Report: PRELIMINARY TAB REPORT

Function: Test, Adjust, & Balance

Date: 10/17/2024

10-14-24 ULTA 1697 SELMA, NC

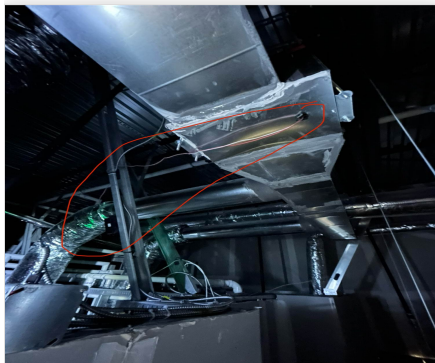
Issue Name : EF-2 Dampers not installed
Description : EF-2 dampers are not installed. However the airflows are proportional so they likely will not be required.
Created By : National TAB **Assigned To :** National TAB - Dan Hertenstein
Status : Open
Priority : Low **Asset Tag :** EF2
Originated Date : 10/17/2024 - Will Turnbough - National TAB

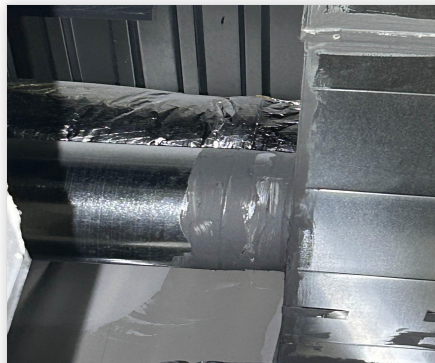
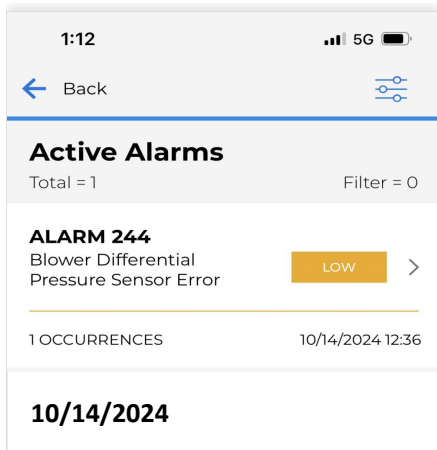
Issue Name : EF-2 Restroom fan unable to access
Description : EF-2 speed controller is located above hard ceiling and is inaccessible. Unable to reach from other side with ladder due to piping obstructing access. The unit is running at 117% of design.
Created By : National TAB **Assigned To :** National TAB - Dan Hertenstein
Status : Open
Priority : High **Asset Tag :**
Originated Date : 10/14/2024 - Jearod Ferrette - National TAB

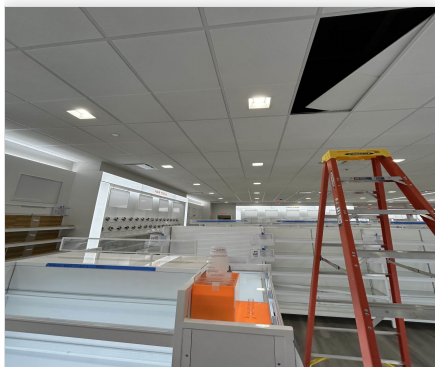
Issue Name : RTU-1 airflow is 84% of design
Description : RTU-1 airflow is 84% of design. The pulley cannot be increased further without the belt sitting too high up on the pulley. A pulley change is recommended.
Created By : National TAB **Assigned To :** National TAB - Dan Hertenstein
Status : Open
Priority : High **Asset Tag :** RTU1
Originated Date : 10/15/2024 - Jearod Ferrette - National TAB

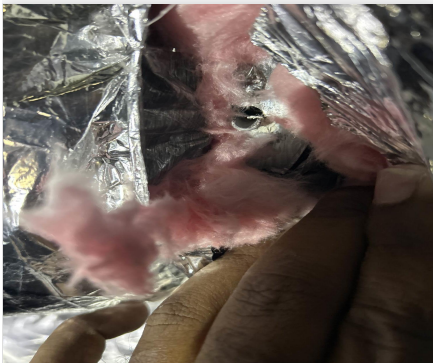
Issue Name : RTU-2 diffuser 24 damper is closed
Description : Damper for diffuser 24 is closed and not accessible. There is a shelf that is directly underneath the damper. Damper is also installed on the top of the duct. It needs to be opened and a face accessible opposed blade damper is recommended in case further balancing is required.
Created By : National TAB **Assigned To :** National TAB - Dan Hertenstein
Status : Open
Priority : Low **Asset Tag :** RTU2
Originated Date : 10/15/2024 - Jearod Ferrette - National TAB
